DEVELOPMENT PLAN FOR  
**TOWNHOMES AT BRADLEY CROSSROADS**  
 4735 Bradley Road, Colorado Springs, CO  
 El Paso County, CO

PROJECT NAME:  
**FINAL LANDSCAPE PLAN**

SHEET NO. / STAMP:  
**L1**

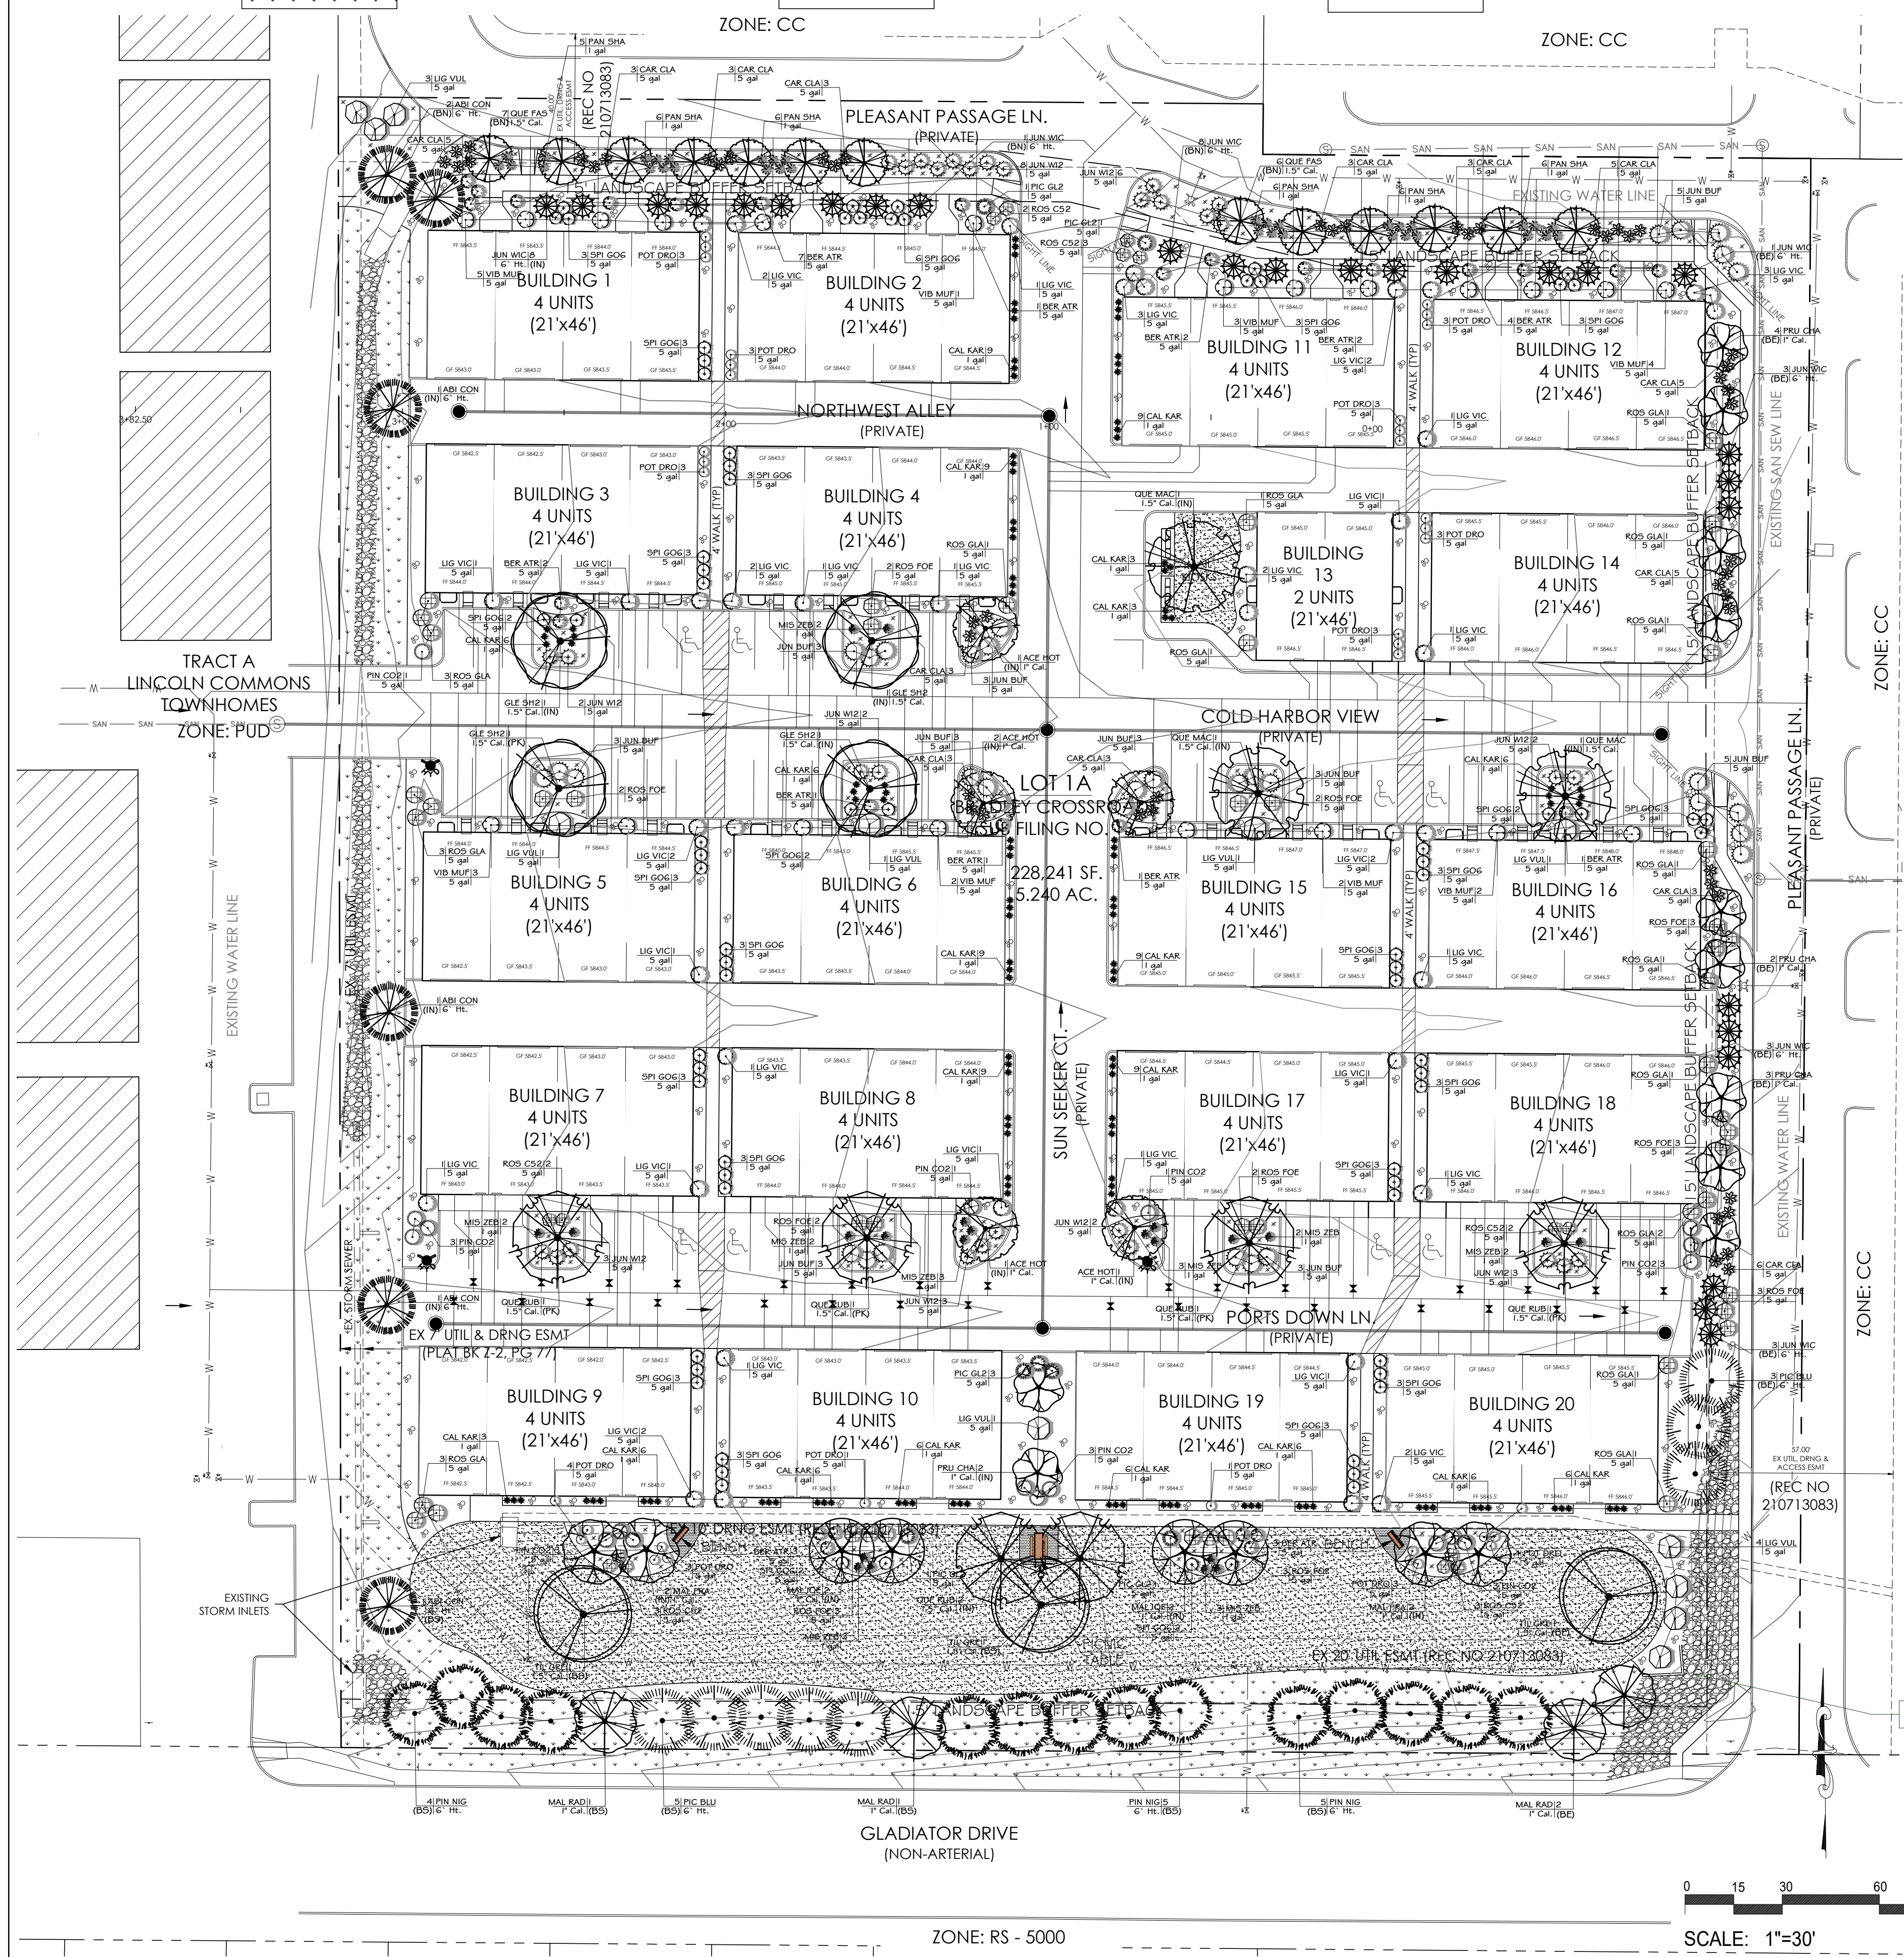
- Is there a more drought tolerant cover grass?  
PROPOSED IRRIGATED BLUEGRASS BLEND SOD
- PROPOSED 5" TO 12" GRANITE RIP-RAP OVER DEWITT LANDSCAPE FABRIC
- PROPOSED 1.5" BLUE GRAY RIVER ROCK COBBLE, 3" DEPTH, OVER DEWITT LANDSCAPE FABRIC
- PROPOSED NON-IRRIGATED 'LOW GROW' NATIVE GRASS WITH EROSION CONTROL BLANKET
- PROPOSED 1.5" ROYAL GRANITE CRUSHED ROCK, 3" DEPTH, OVER DEWITT LANDSCAPE FABRIC
- PROPOSED COMPACTED RED BREEZE GRAVEL, 3" DEPTH, OVER DEWITT LANDSCAPE FABRIC

Please see SDP comments and apply as appropriate

Is there lighting other than wall sconces? If so submit lighting plan and photometric

Delete this (this is for a final approval for zoning / dimensional standards)

parking calc need to be verified with bedrooms

Buffers are different from roadway landscape (relate to combine) The higher standard is required 6.2.2.G.2. (h) - page 6-15

ROADWAY LANDSCAPING CATEGORY (NON-ARTERIAL) 10 foot setbacks adjacent to all private roads and the public roads (driveway alleys do not require)

high water user to establish is this appropriate

please consider incorporation of more drought tolerant species.

is this cobble?
